FrutaMIDI: capacitive USB MIDI controller

Engineering report

FrutaMIDI v1.3 (change request CR-003), interfaces frozen-9 (frozen), requirements draft-16, 2026-11-11

3 PCB v1.3: single-sided SMD board (CR-003)

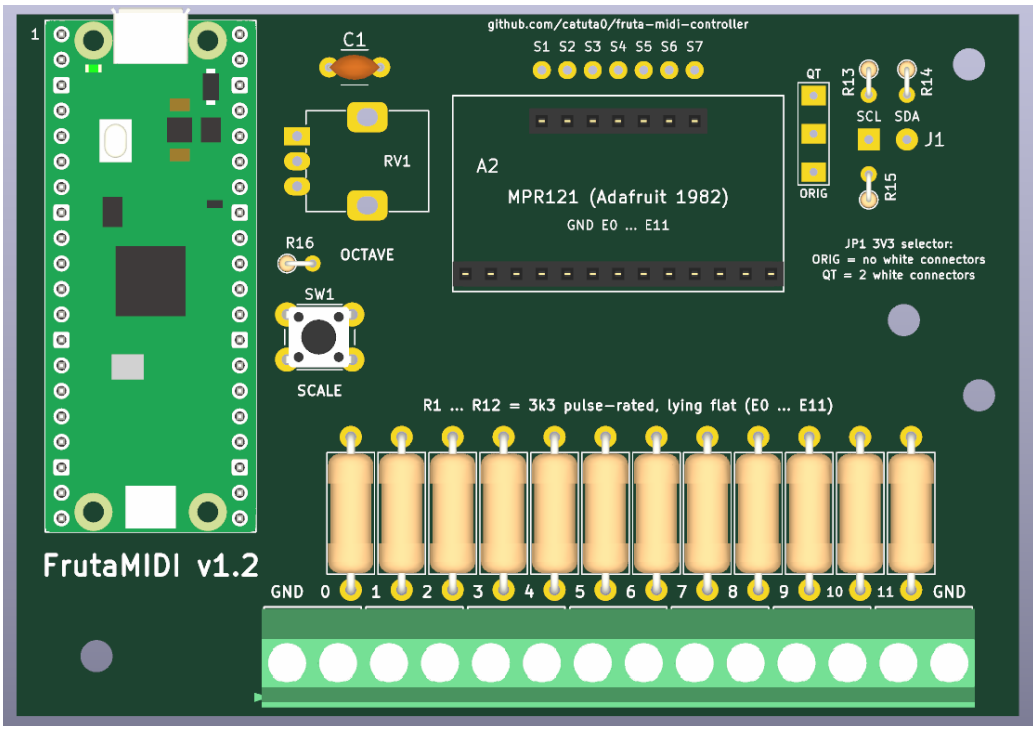
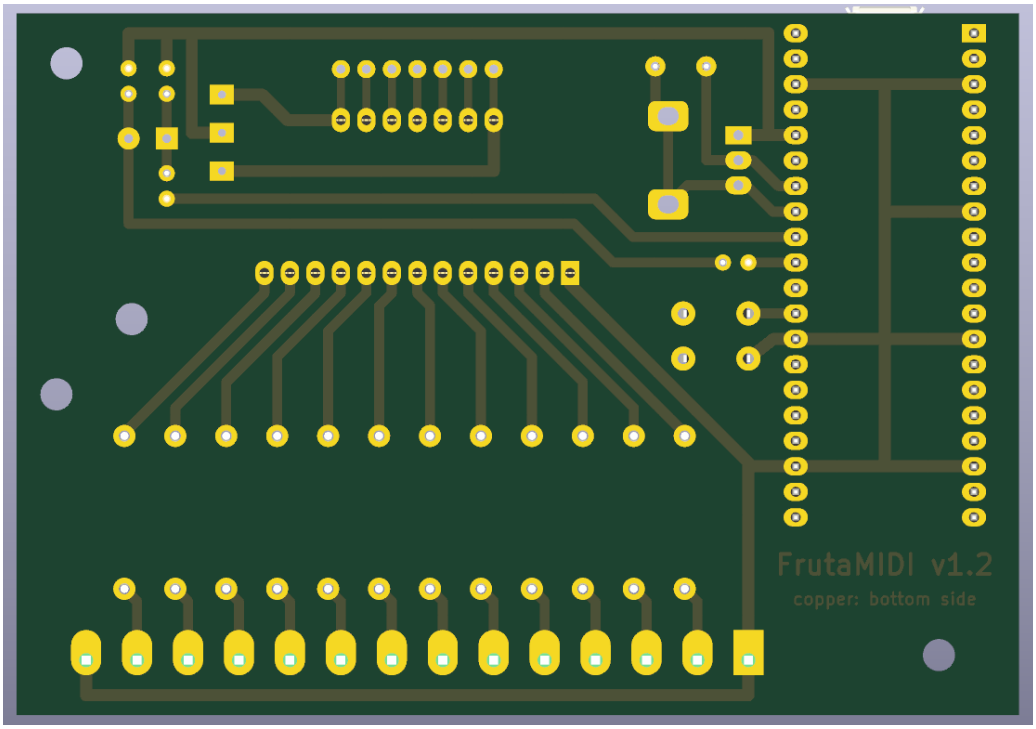
C2-004	info	Independent chart reading confirms 4086 / 1740 / 1469 V; dimensions, LSR37 data and part number agree.	No action.
C2-005	minor	Every E terminal pad is 1.40 mm from the GND edge track, so a strike most likely arcs to GND; the current through the GND trunk to Pico, module and USB was not analysed.	Accepted risk: intentional spark gap; ground bounce 87–339 V for ≈1 ns, ≤1.53 A and ≤0.92 nC per 220 Ω I^2C resistor (CALCULATION on ASSUMPTIONed inductances); arc to GND added to the ESD test; GP26/GP27 HBM rating not confirmed (open).
C2-006	minor	Stale evidence: committed `interface_check.out` 79/80; REQ-028/029, requirements.csv and INTERFACES frozen-4 notes describe 3a3684b.	Fixed by systems (T-074): `sim/systems/*.out`, REQUIREMENTS, INTERFACES frozen-5 (committed in 2ba289a).
C2-007	minor	Assembly guide offered any resistor lead off-cut for JP1 (0.8 mm holes); R1–R12 leads are 0.8 mm.	Fixed: solder or an off-cut of an R13–R16 lead (0.5 mm) only.

C2-008	info	1.0 mm drill for a 0.8 mm lead sits exactly on the 0.2 mm fit threshold; generator comment wrong.	Fixed: R1–R12 drill 1.1 mm (ring 0.55 mm); comment corrected.
C2-009	info	Courtyard gaps 0.06 mm (R row to J2) and 0.09 mm (R12 to H3); M3 head about 0.5–0.9 mm from R12.	Fixed: H3 moved (95, 48) → (96, 38) mm; bypass 1.94 mm FAIL → 15.36 mm PASS; nylon hardware recommended.
C2-010	info	Terminal labels "10" and "11" touch R10/R11 pad 2 (about 0.1 mm).	Fixed: worst silkscreen-to-pad gap 0.43 mm.
C2-011	info	`check_gap.py` worst-pair name not deterministic on ties.	Fixed: tie-break by reference, then pad.
